# NEWMAR CORPORATION WARRANTY DEPARTMENT

TSB# 353

**Subject:** Potential lack of drainage in drivers side power window frame.

**Affected Units:** Certain 2009 MADP, EXDP, and KGDB units built between 11/5/07 and 7/21/08 with the standard drivers side front power window.

Figure 2: Drivers Power Window Assembly

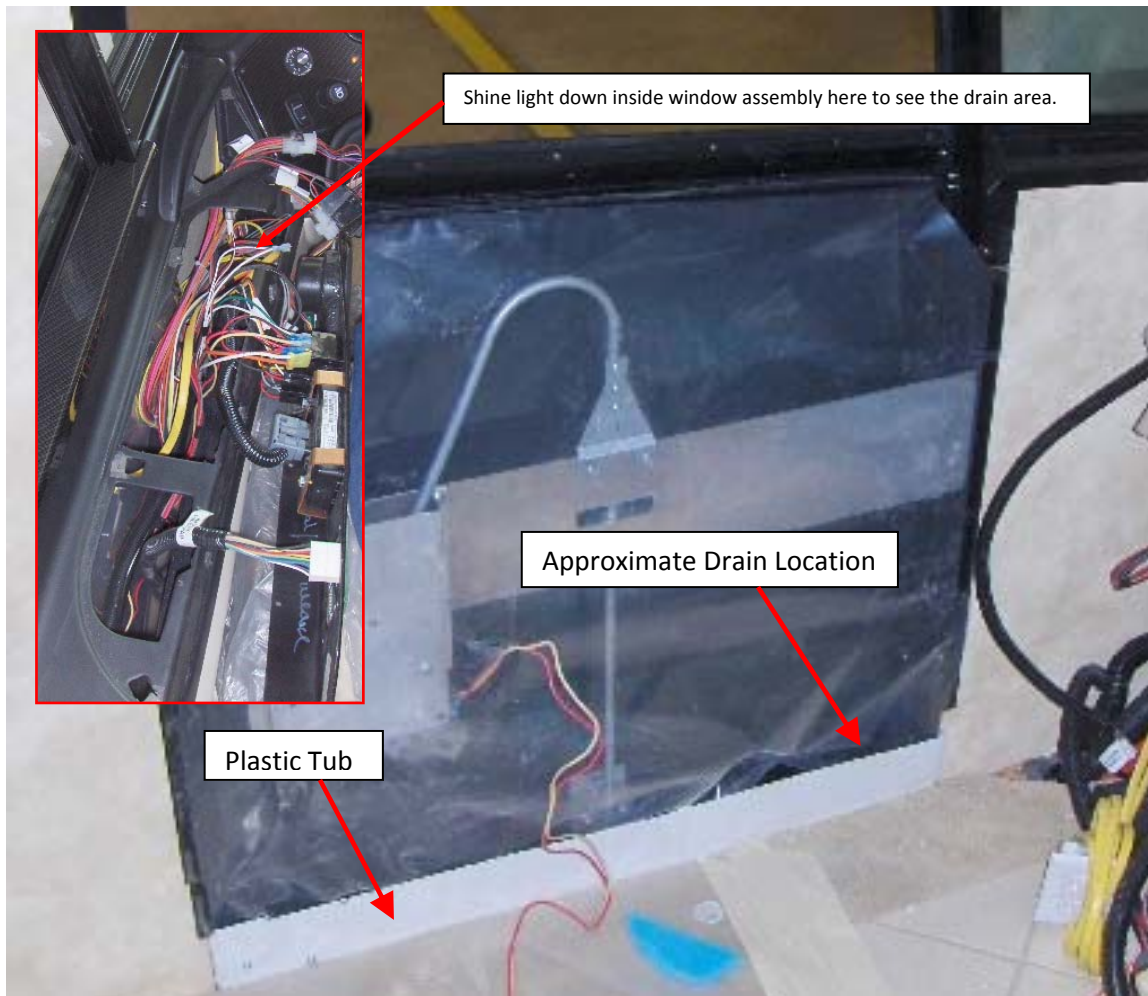
This illustration shows the window frame assembly sitting in the plastic tub. The drain is located toward the front of the window frame assembly (see figure 3). Shine a flashlight down into the opening to see if the drain hole has been drilled. **If there is no drain hole in the black metal window frame, one will need to be added.**

Figure 4: Drain Hole Detail

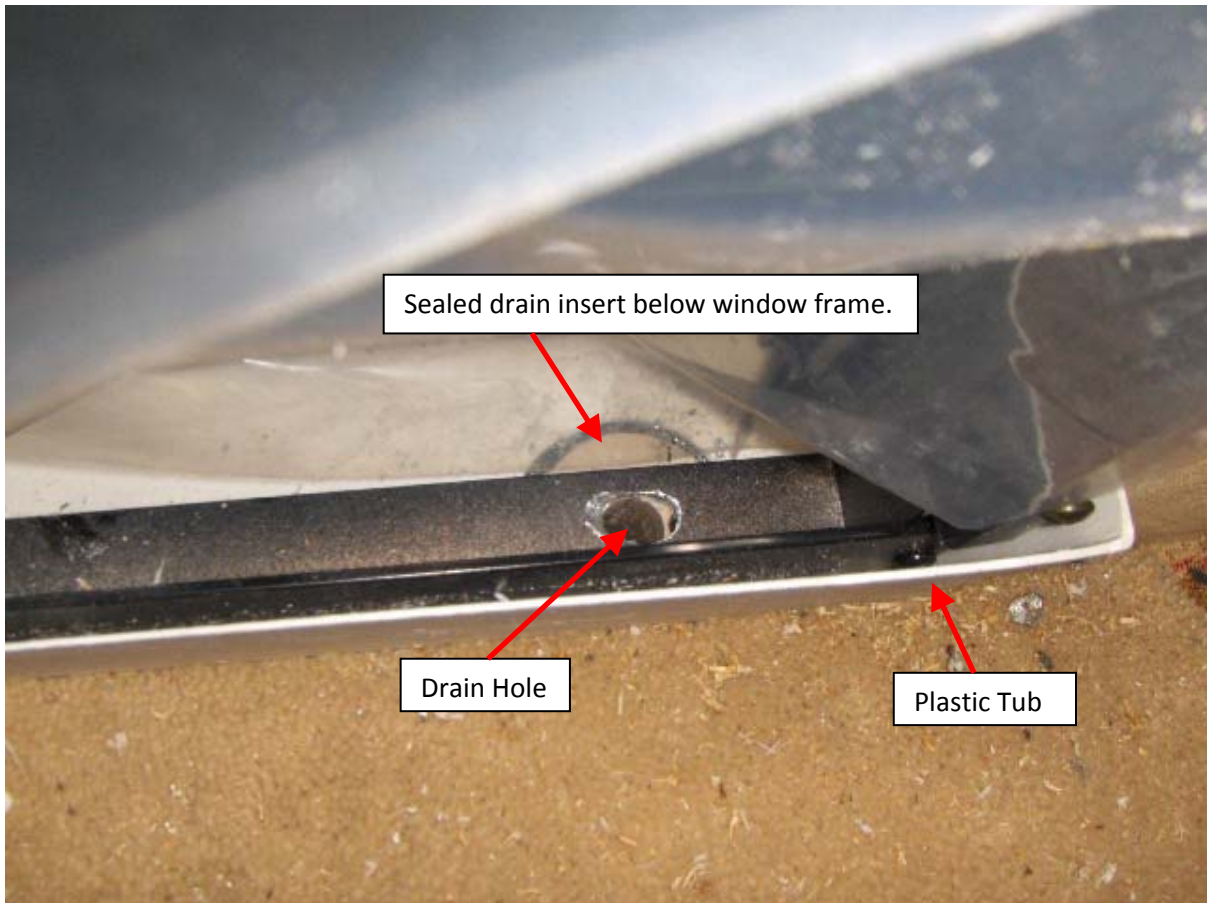
Figure 4 shows detail of where and how the drain hole is positioned. The plastic tub has a drain insert installed that runs through the floor structure to the front wheel well area. This is a sealed insert to channel the water out of the plastic tub without seepage onto the floor. If there is a drain hole drilled in the black metal frame, inspect it to be sure it is clear of any debris and re-install the driver's side armrest. No further action is required.

If no drain hole is located in the black metal frame here, visually locate the insert in the plastic tub below the window frame (see figure 4), and drill a 1/8" pilot hole visually centered over the insert. Once the pilot hole has been drilled, drill it out

to size using a 7/16" drill bit. Clear the hole of any debris or shavings that might plug it, or in any way restrict the flow of the drain.
